Approved Section 4.55 (.....2.....) Modification Application

In respect to.....SSD 7484.....

SANDSTONE PRECINCT
23-39 BRIDGE STREET
SYDNEY, NSW, 2000

DEMOLITION ELEVATIONS LANDS BUILDING - SOUTH AND EDUCATION BUILDING - SOUTH

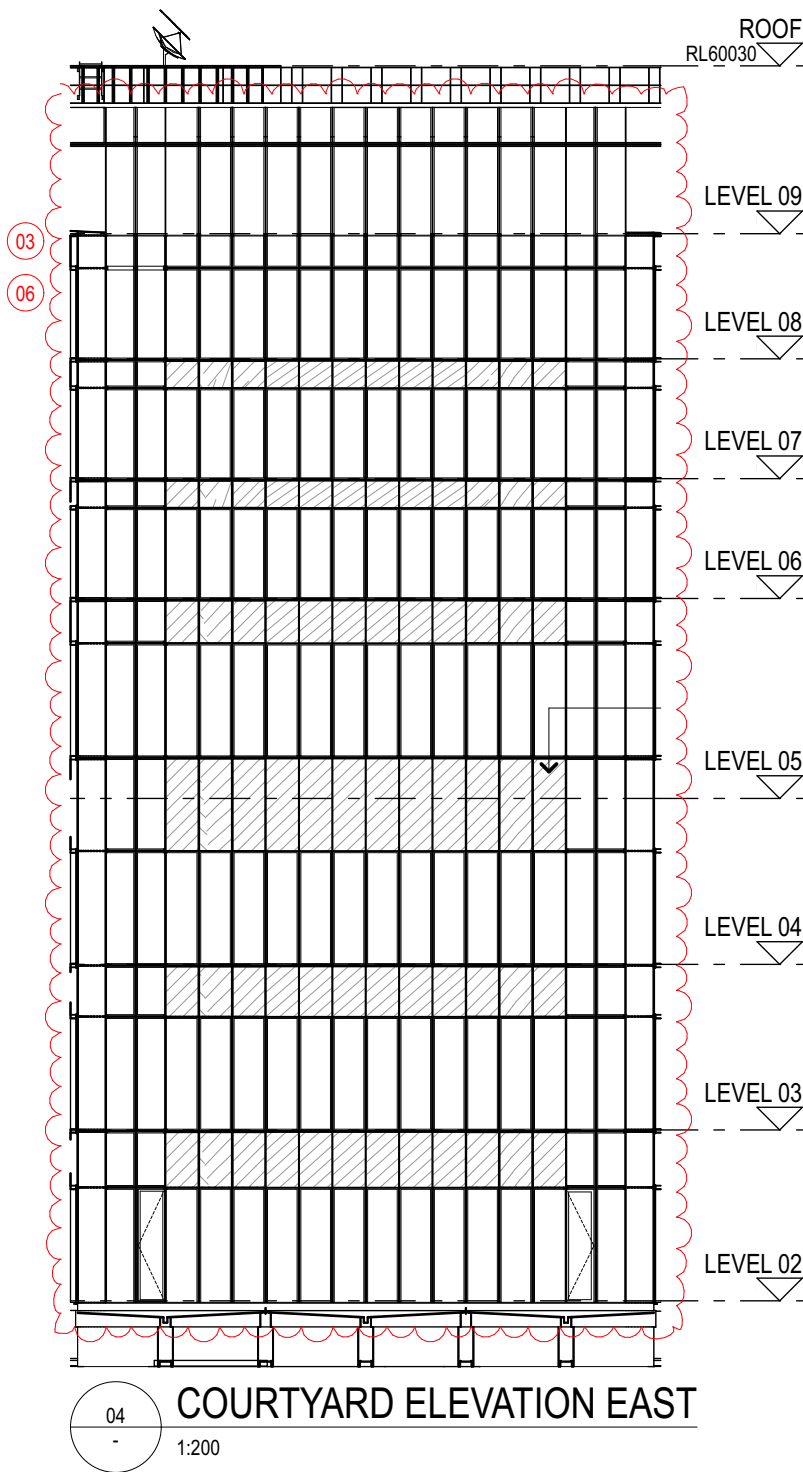
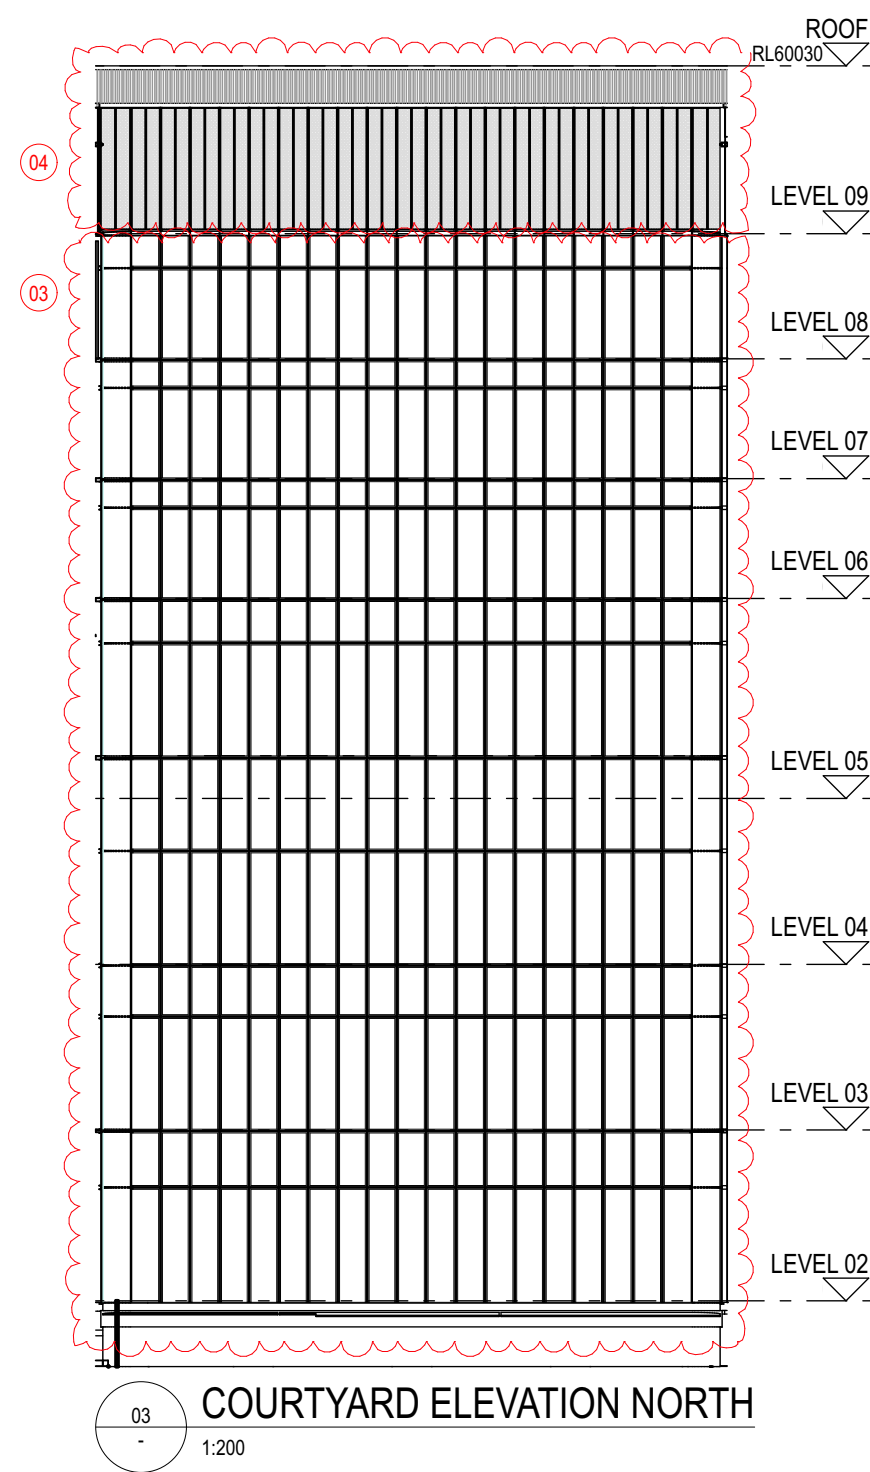
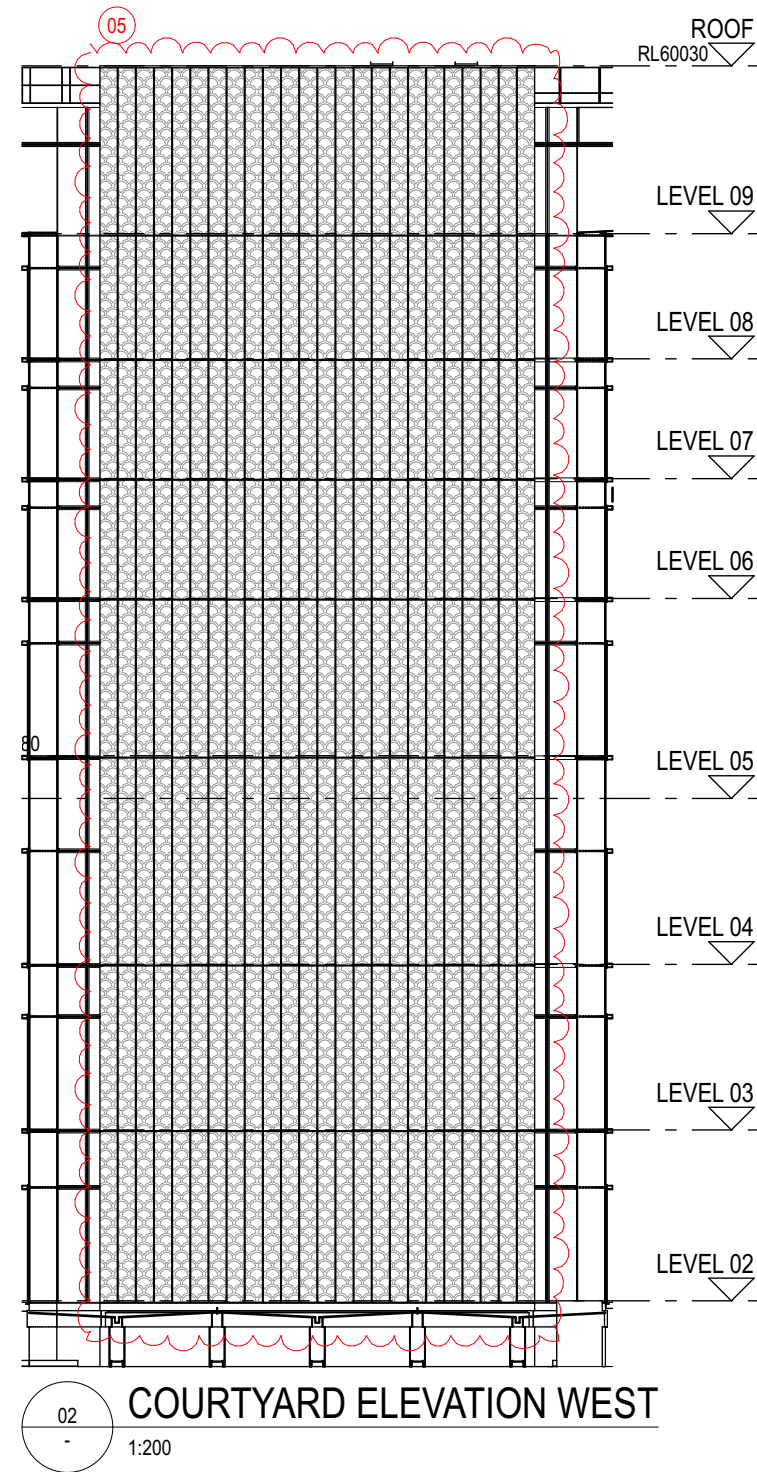
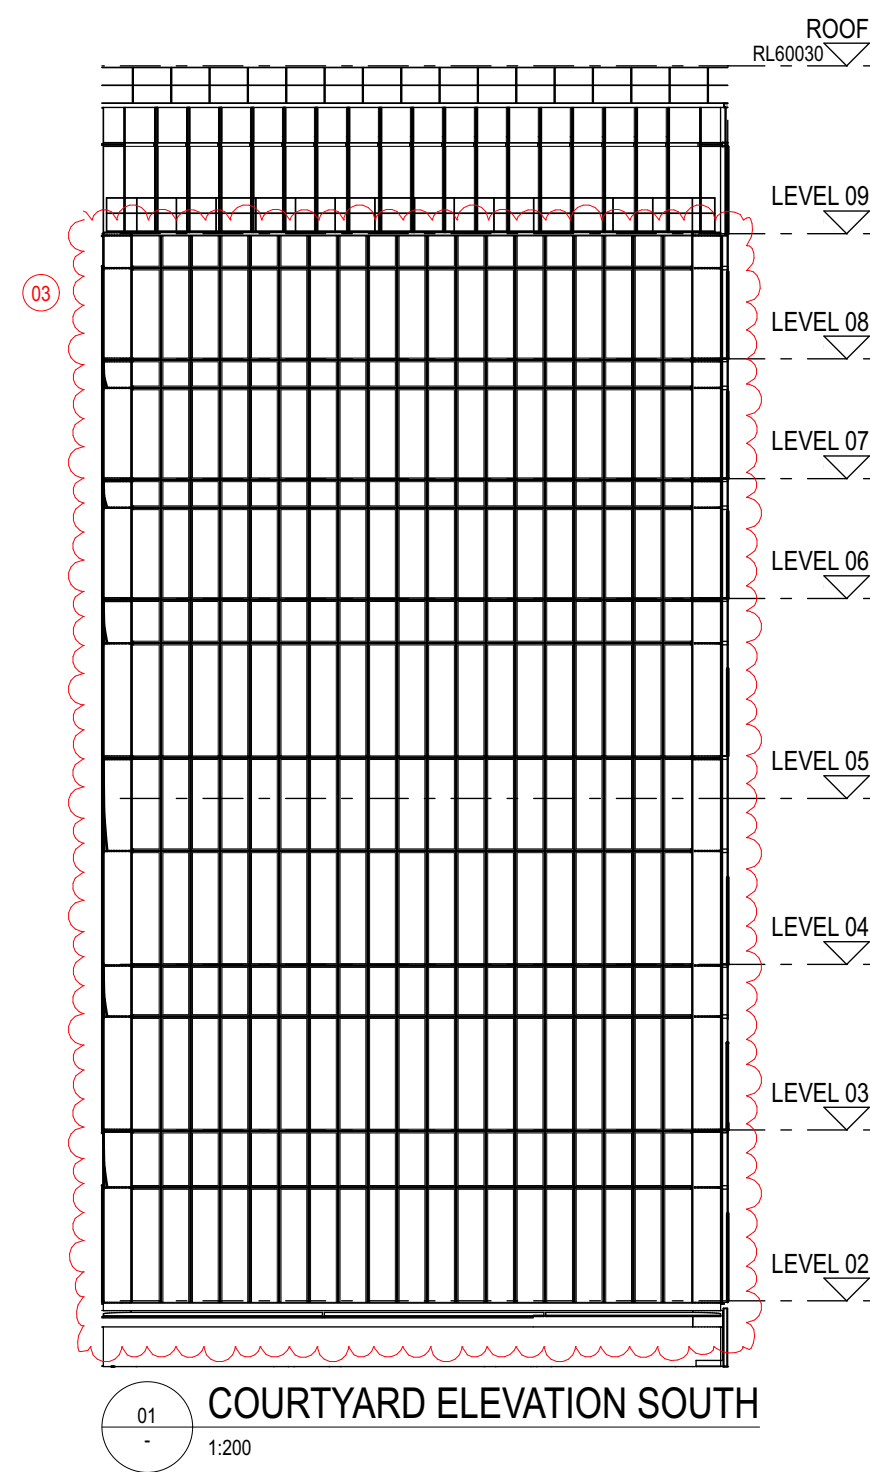
- CHANGES LEGEND:
- 01 COOLING TOWER ROOF UPDATED
 - 02 PAVING & FINS LOCATIONS REVISED
 - 03 REMOVED FINS ON CURTAIN WALL, MULLION SETOUT REVISED
 - 04 ADDED PERFORATED PANEL ON LEVEL 9
 - 05 REPLACED FLUTED FACADE WITH FLAT DECORATIVE PANEL
 - 06 ADDED CURVE AWNING

01 LANDS BUILDING - PROPOSED SECTION LOOKING NORTH
1:200

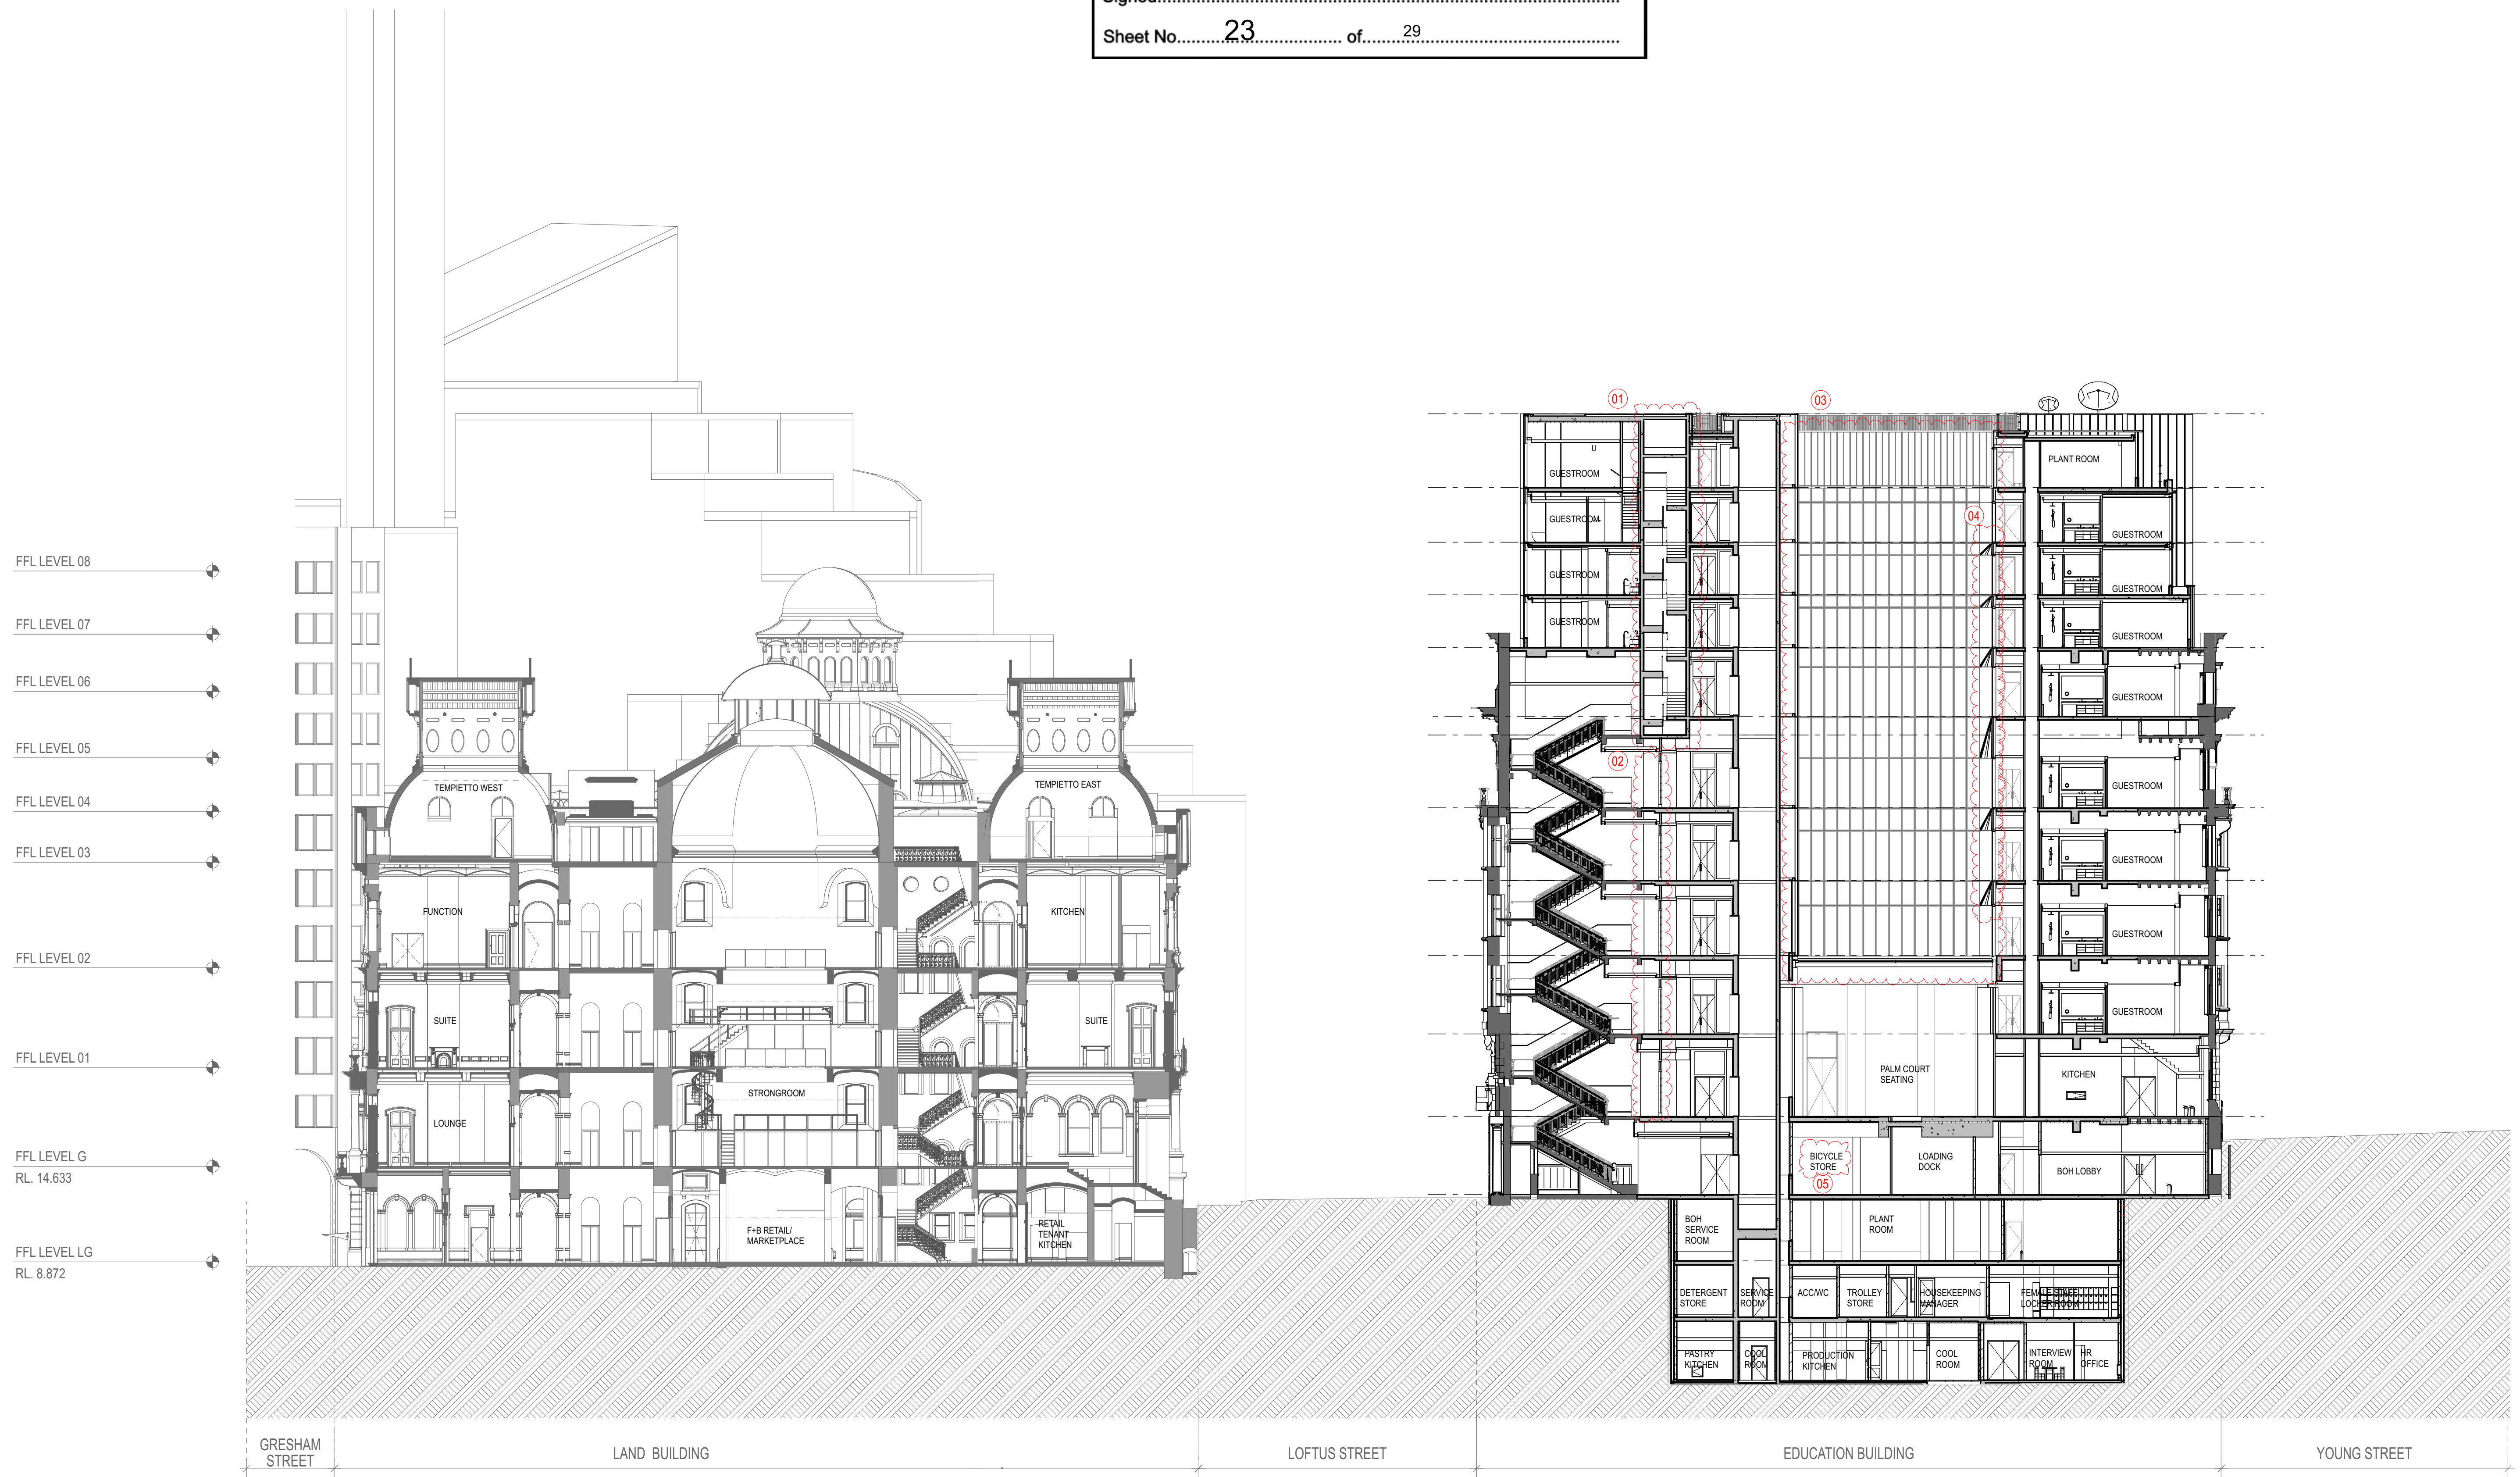
01	STAIR RE-DESIGNED
02	DOOR RELOCATED
03	REMOVED FINS ON CURTAIN WALL, MULLION SETOUT REVISED
04	ADDED CURVE AWNING FACADE
05	ADDED BICYCLE STORAGE
